### ERICKSON WATER SYSTEM – WATERMAIN REPLACEMENT

#### ADDENDUM NO. 4

Issued: January 9, 2025

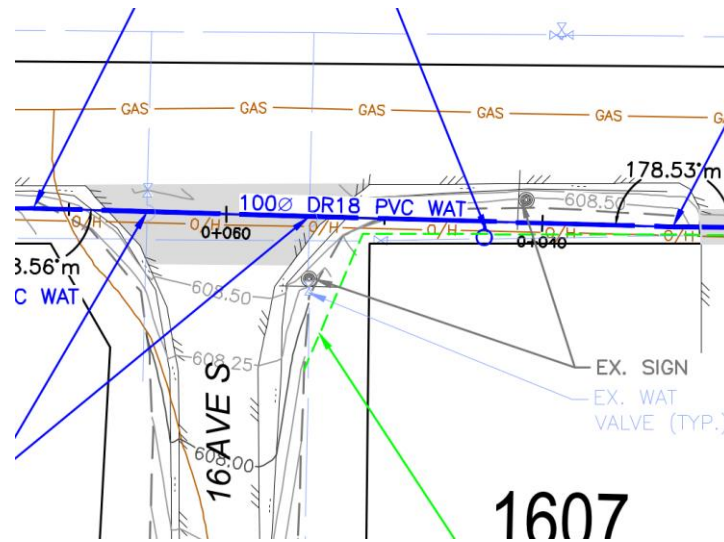
**Q10: Can you reiterate what was said onsite which was that the intent is to limit and possibly eliminate Hwy paving?**

*A10: During the onsite tender meeting, it was mentioned that the proposed asphalt disturbance area on Erickson Road is shown in a grey hatched/shaded area in the tender drawing package – see example of the grey hatch/shaded area in the snapshot below (at the watermain crossing situated at the intersection of Erickson Road and 16th Avenue South).*
